Access Compliance Report

Public Rights-of-Way

Intersection ID: 9848	Main Street: THE_PLAZA	Cross Street: WILANN_DR	Location: NE
ADA ID: 9860AFA93843	Ramp Type: Perp	Initial Pass/Fail: Fail	Overall Compliance: No
		Severity Score: 25

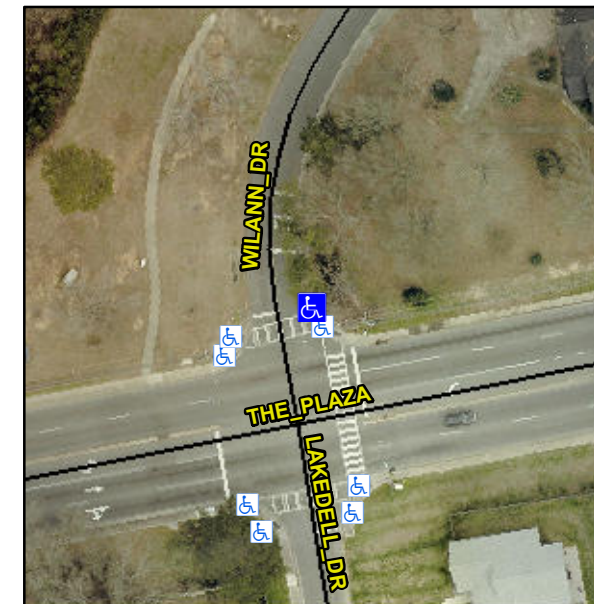
Not Found, R304.2.2

Compliance	Description	Data	Compliance	Description	Data
N/A	Ramp Length (in)	59.5	No	Ramp Slope (%)	12.1
Yes	Ramp Width (in)	48.0	Yes	Ramp XSlope (%)	0.8
N/A	Flare Type LT	N/A	N/A	Flare Type RT	N/A
N/A	Flare Slope LT (%)	N/A	N/A	Flare Slope RT (%)	N/A
N/A	Flare Traversable LT?	N/A	N/A	Flare Traversable RT?	N/A
N/A	Landing Length (in)	N/A	N/A	DWS Provided?	N/A
N/A	Landing Width (in)	N/A	N/A	DWS Contrast?	N/A
N/A	Landing Slope (%)	N/A	N/A	DWS Length (in)	N/A
N/A	Landing X Slope (%)	N/A	N/A	DWS Full Width?	N/A
N/A	Landing Curb? (Y/N)	N/A	N/A	DWS Offset (in)	N/A
N/A	Shared Landing?	N/A			
N/A	Gutter Ponding?	N/A	N/A	Gutter Slope (%)	N/A
N/A	Gutter Lip Ht (in)	N/A	N/A	Gutter X Slope (%)	N/A
N/A	Painted X Walk1?	Yes	N/A	Painted X Walk2?	N/A
	X Walk 1 Direction	To W		X Walk 2 Direction	N/A
N/A	X Walk 1 Width (in)	111.5	N/A	X Walk 2 Width (in)	N/A
	X Walk 1 Slope (%)	1.6		X Walk 2 Slope (%)	N/A
	X Walk 1 X Slope (%)	3.4		X Walk 2 X Slope (%)	N/A

Remove & Replace Entire Ramp.
